ADDENDUM DESIGN STATEMENT

Change of Use to Upper Floors and Alterations
to create 46 Bedroom Hotel

1-3 York Street, Manchester

Fig 2: Section through a typical room at 2nd floor level showing ceiling reduced at room perimeter, and bed head ‘shelf’ around existing chimney breast, allowing the original room volume to be read.

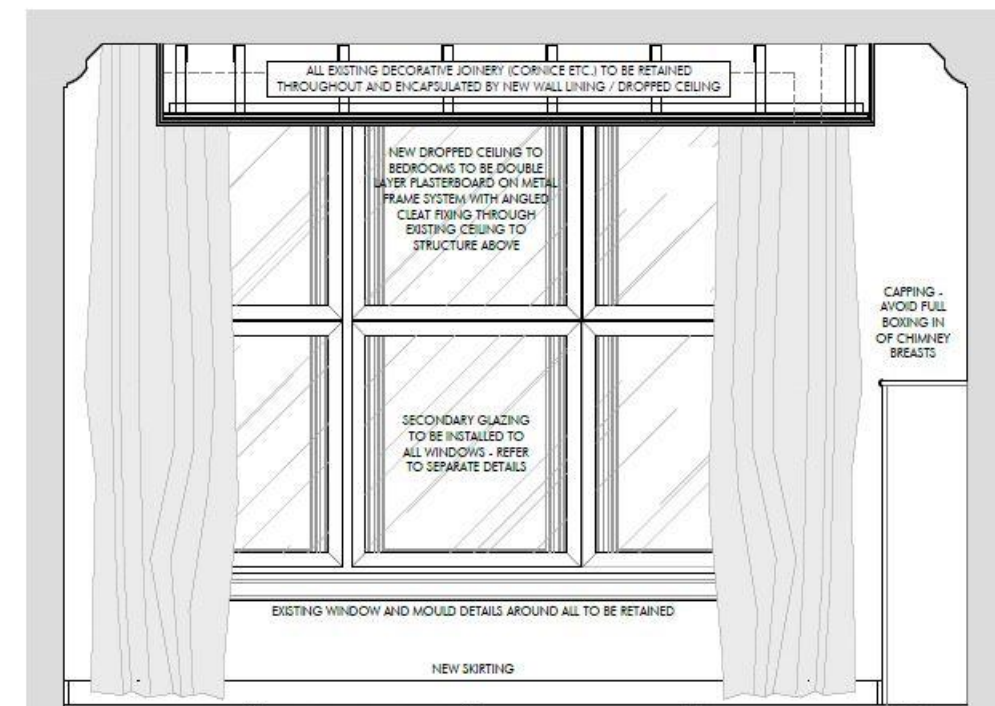
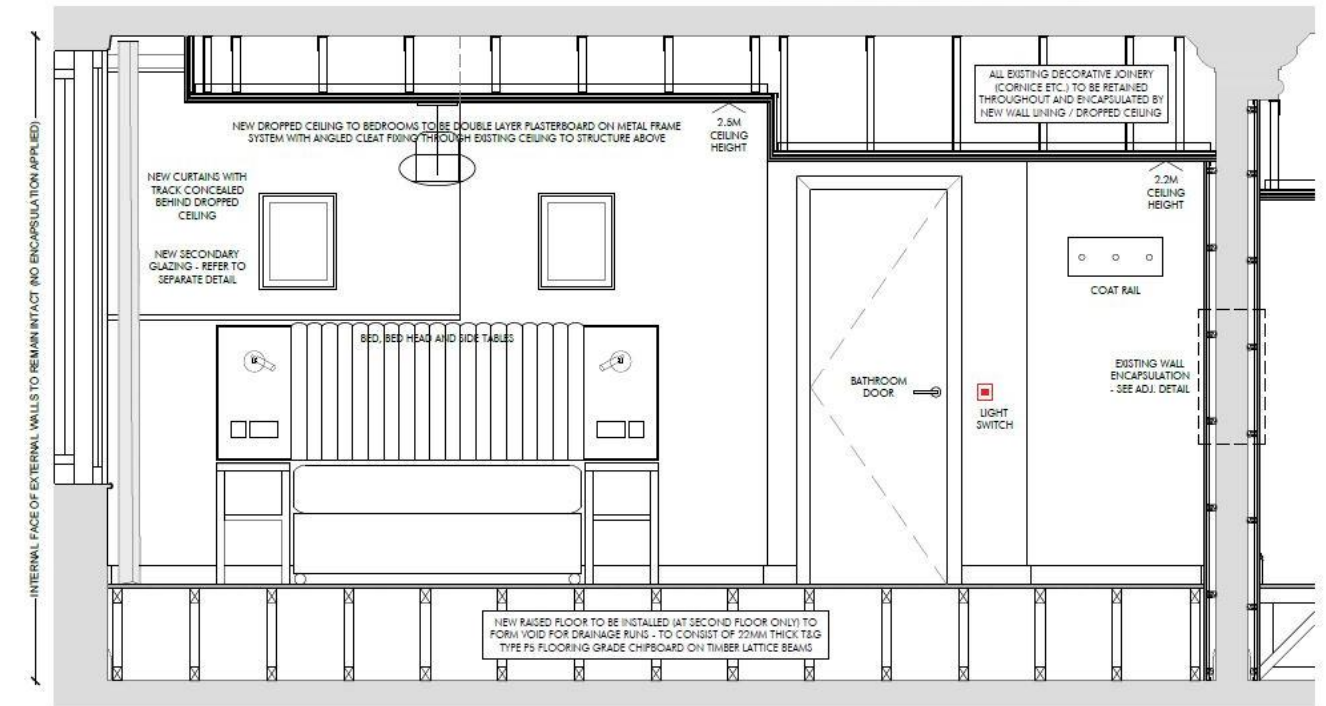
- Ceilings within bedrooms have been minimised, with the new ceiling limited to the centre of the room space, with the existing room space perimeter cornice exposed (see illustration opposite)

- Services (air conditioning pipes, hot & cold water and electrical cables) will be required to enter the ceiling void from the corridor into each bedroom, which still requires a lower section of ceiling within the bedroom to allow pipework to pass through into the room without damaging the cornice above. This section of ceiling will abut existing cornicing.

- Fixings shall be made into masonry walls only and not pass through cornice plaster details or finished joinery – ensuring insertion works are reversible with no detrimental impact on existing features.

- Bedroom walls shall no longer be lined with plasterboard, instead any electrical connections shall be ‘chased’ into existing masonry walls and the surfaces made good. This enables all existing cornices at ceiling level and all existing skirting boards at floor level to be exposed and repaired/repainted as necessary. The only exception is the corridor walls at second and first floor levels where a raised floor is to be installed and existing skirtings shall no longer be exposed.

Fig 4: Plan detail of proposed raft (looking upwards)

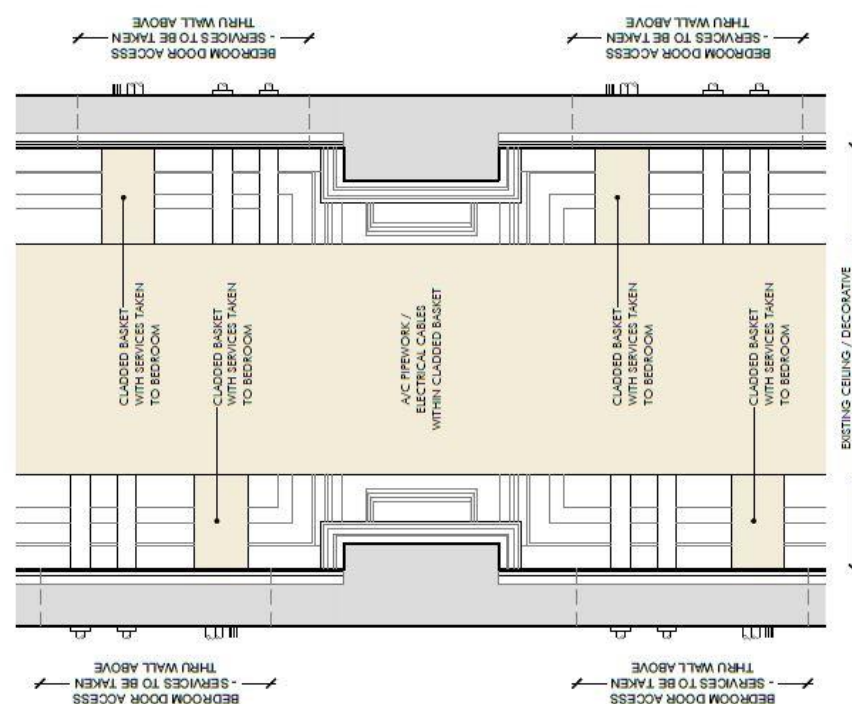
The main pipe and cable services shall run in ceiling trays with a decorative raft running through the centre of the corridor . This raft can incorporate LED strip lighting to illuminate the volume of the space. All decorative archways at second floor level can now be exposed and the full volume of the original corridor space can be appreciated. Hot and cold water services will run at high level in the upper open space and will be treated with a white wrap product (illustrated below) to improve the appearance where they may be visible either side of the central raft.

Fig 5: LEFT: previous corridor services strategy; RIGHT: Proposed services strategy introducing corridor ceiling rafts. Void spaces are highlighted in red.

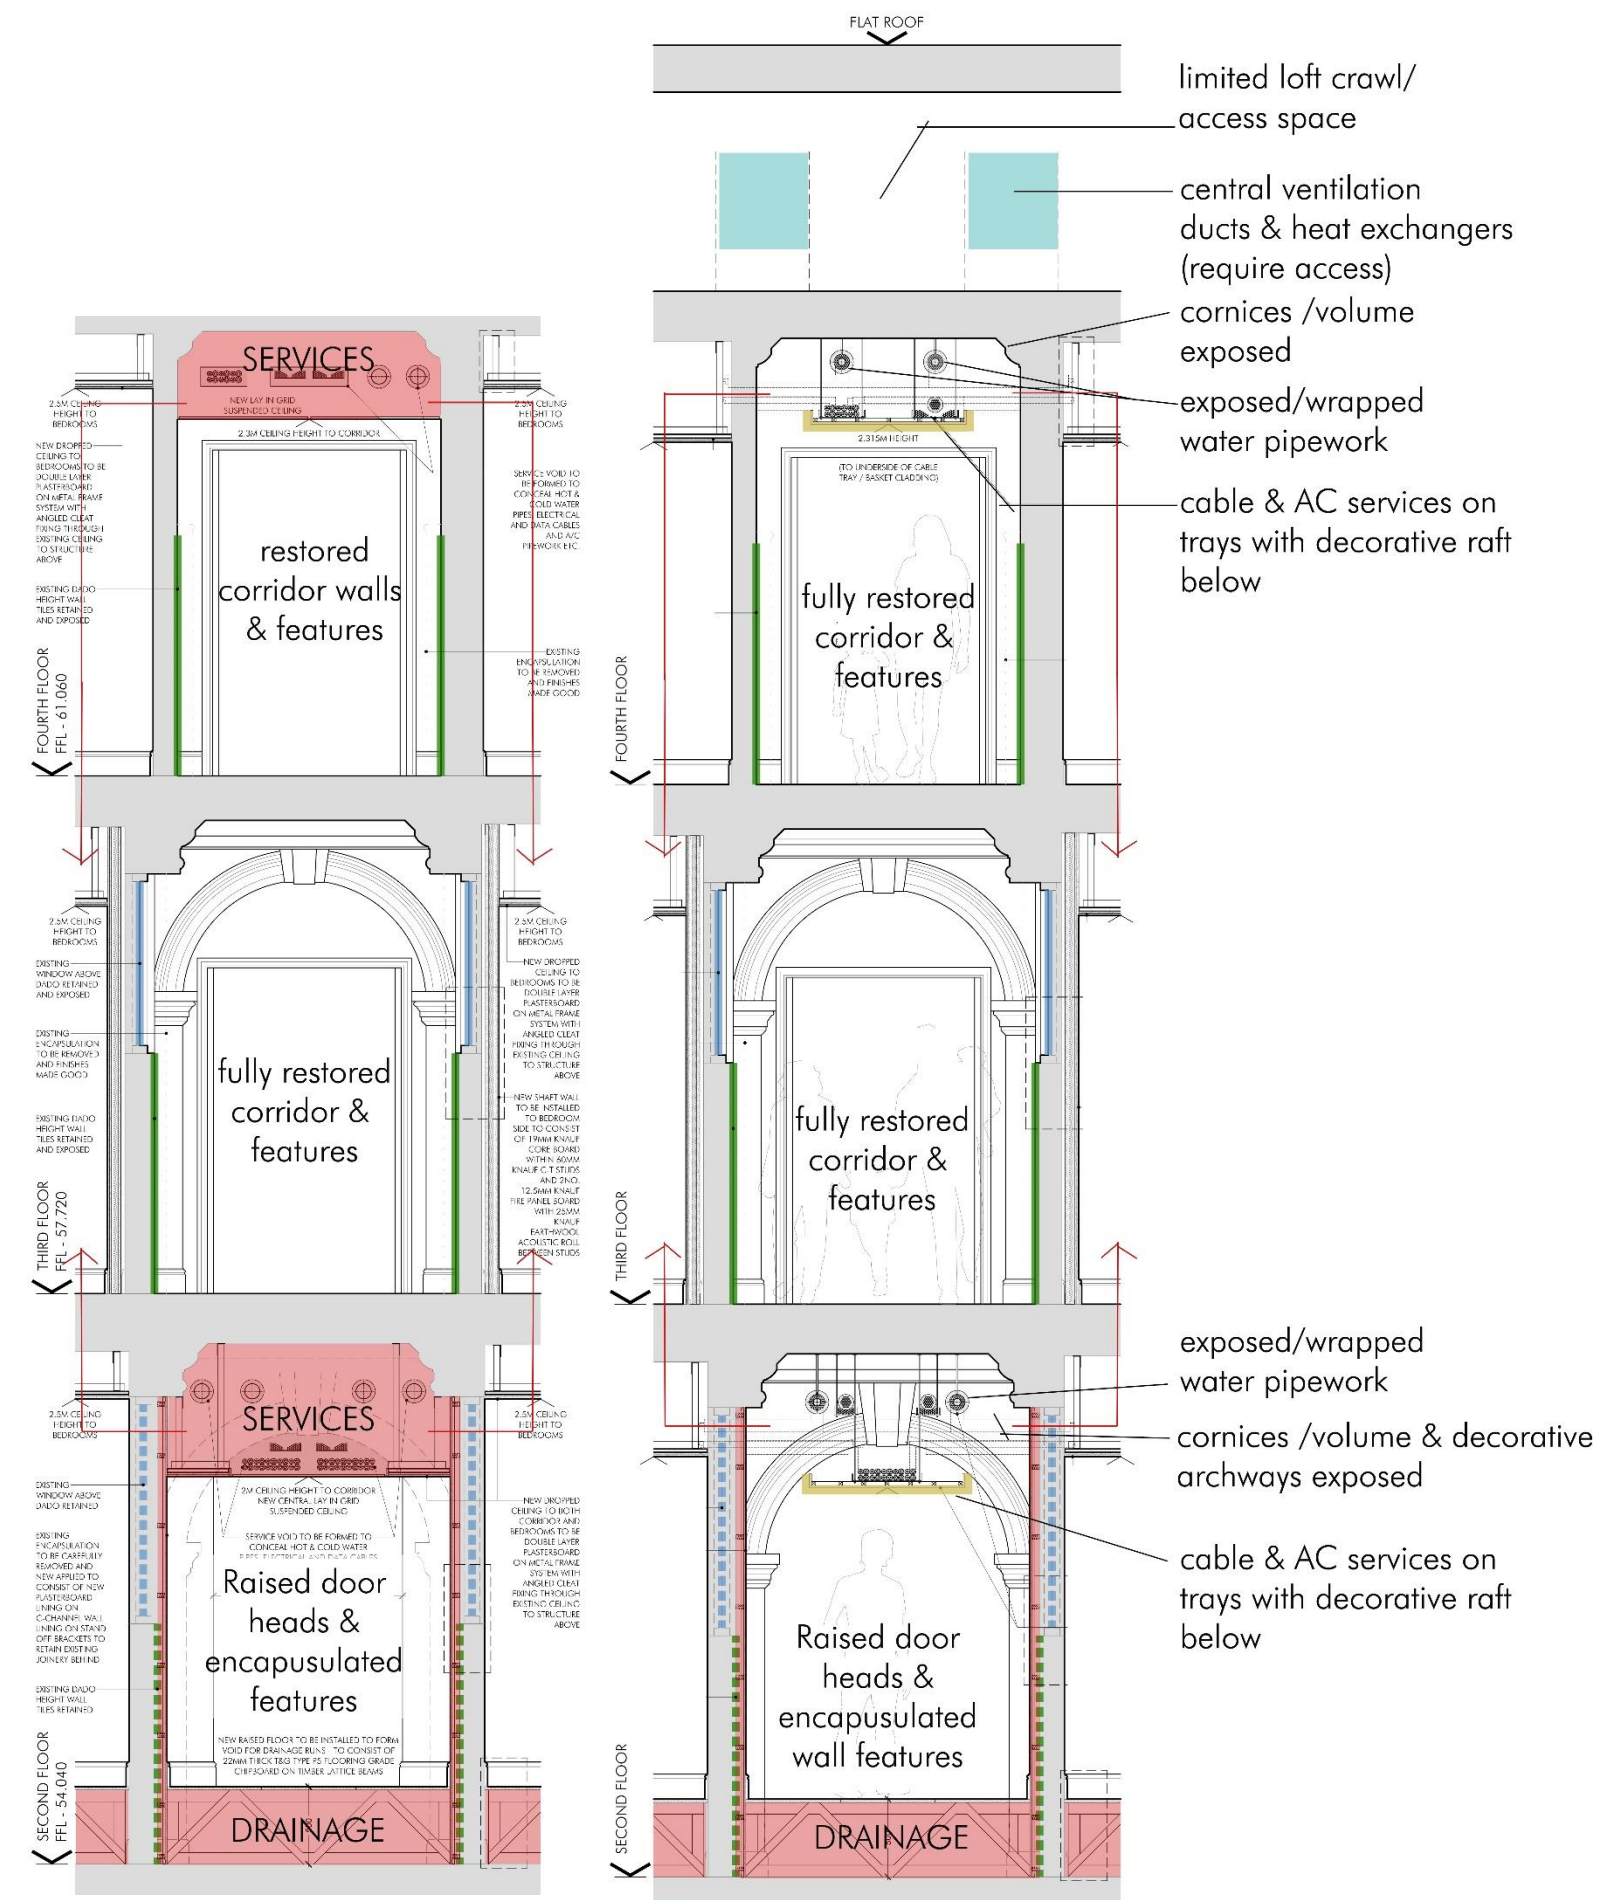
Following detailed consideration, we have redesigned the services distribution within the corridor ceilings to achieve the requested principle of carrying services on 'rafts' rather than boxing-in the full ceiling zone. The illustrations (opposite) show clearly the difference between the original approach and this revised proposal. The fundamental distribution principles for the whole building have not changed – services are concentrated at second and fourth floor level with vertical feeds through the bedrooms to enable the corridors at third floor level to be fully restored.

Fig 6: Area at second floor (shown grey on plan) where there are no original corridor features remaining – this has been opened-out in the 1980s with a concrete or steel frame structure inserted in the space – proposed to have a fully enclosed ceiling.

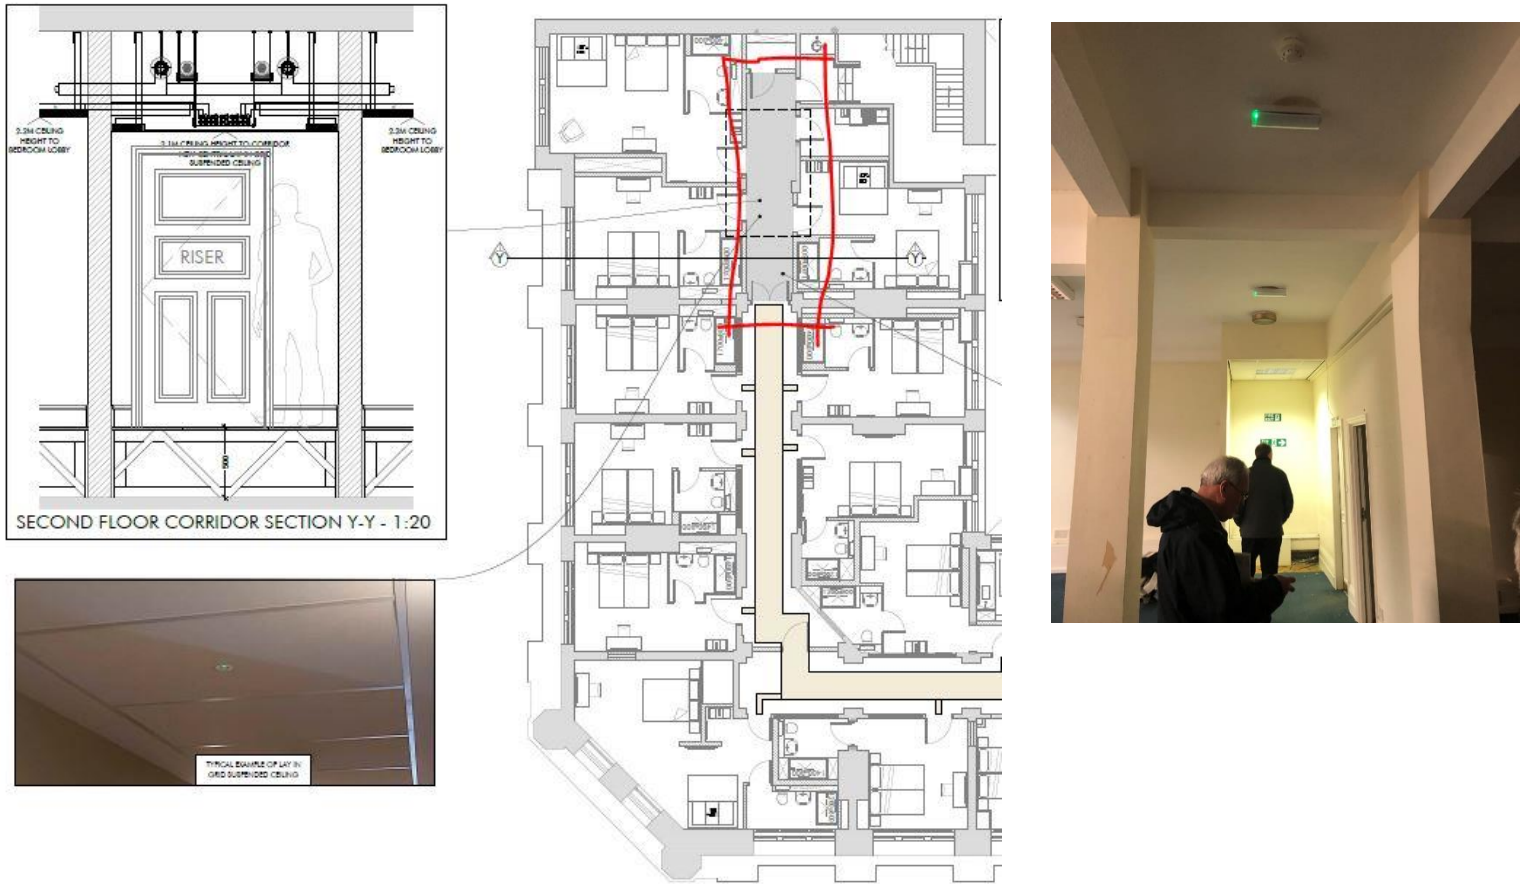
Firstly at the end of the second floor corridor (illustrated right), where there is no original ceiling detail. This was ripped-out in the 1980s and the space opened-out with concrete or steel columns and beams (see photo). This area has the largest concentration of services distribution, therefore we are proposing a small area of fully enclosed ceiling where there is no original ceiling detail to reveal.

Fig 7: Area at second floor (highlighted on plan LEFT) with no raft to ceiling or raised floor.

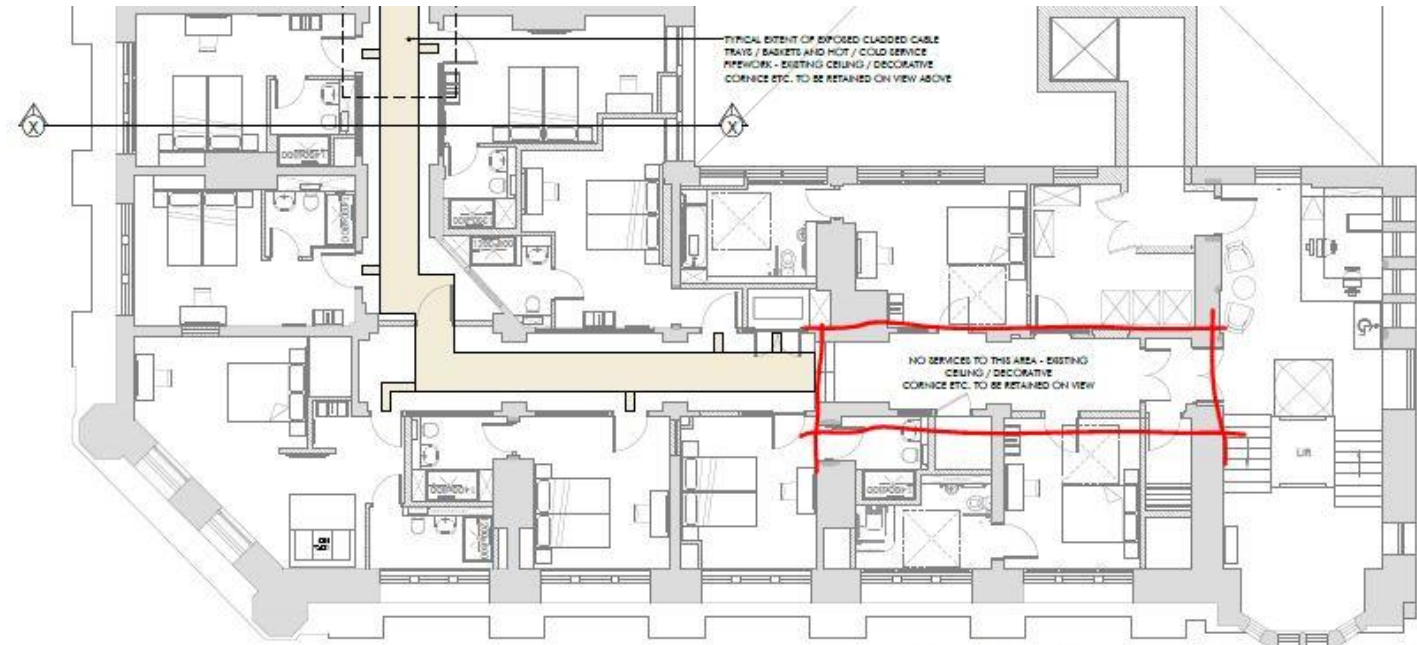
Secondly, also at second floor, the area of corridor immediately leading from reception does not require a raised floor therefore, as in the original application drawings, we are proposing to fully restore that section of corridor, including the tiled walls, and route services through the rooms either side of it. This results in a larger section of bulkhead ceiling in those side rooms, however there is a clear benefit to the user experience of the building by allowing that section of corridor to be restored.
